2 Contents3 Cutblock

Introduction

On December 11, 2019, Ches Clem, Planning Forester, BCTS Kamloops Business Area, requested that RDI proceed with Visual Assessment of an update of the Albreda Operating Area, providing new data. Ches also provided new cutblock data for the Dominion Operating Area the next day. In his engagement letter e-mail, Ches also indicated that he would take new photographs. RDI provided a spreadsheet of viewpoints to guide the photography tour by Ches. RDI also provided a geo-tagged map of the viewpoints to facilitate viewpoint accuracy in the field for Ches. The two operating areas are contiguous and somewhat overlapping with Dominion to the southeast and Albreda to the northwest, on opposite sides of Highway 5. Combined viewing opportunities for the two areas stretch at total of 21km along Highway 5, 13km for Albreda and 8km for Dominion, including a 3km overlap where glimpses of the Dominion Operation may potentially be seen through the trees.

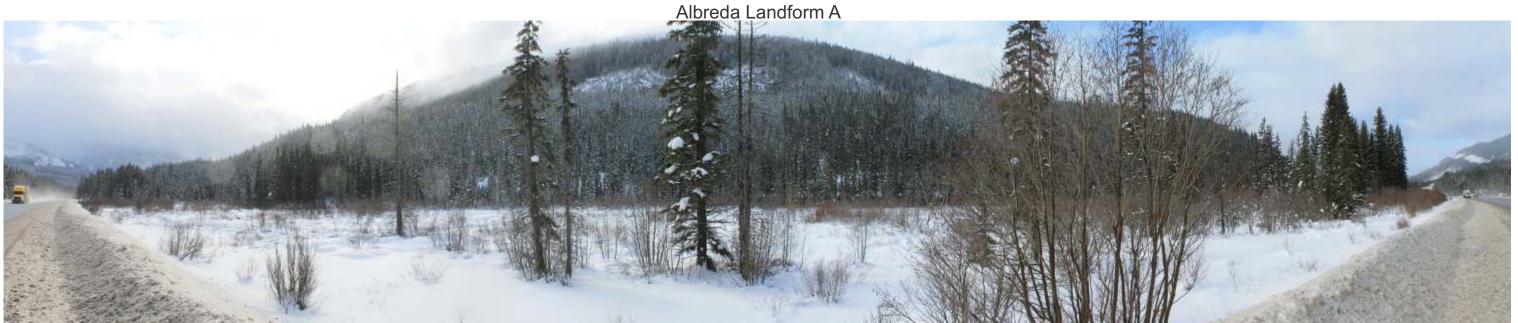
Ches Clem comment February 18, 2020:

For viewpoint 7 I agree that your model accurately depicts the road side screening.
